NEI 17-06 Changes

Draft B vs Rev 0

14 May 2021

Overall Methodology

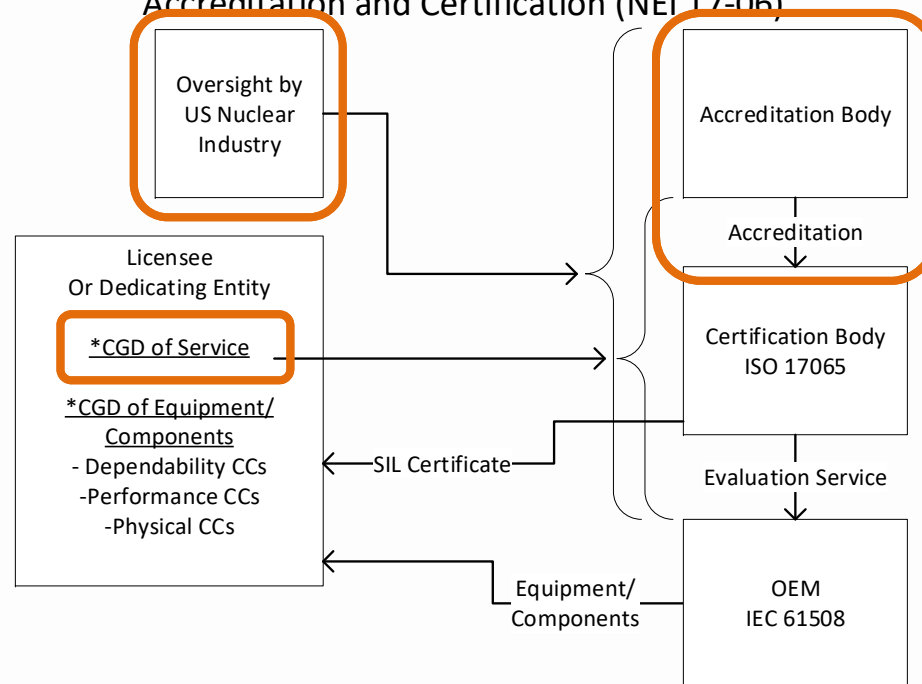
- Incorporated use of the services CGD for certifying body
- Added new Section 4.2- Determination of SIL for End User's Application
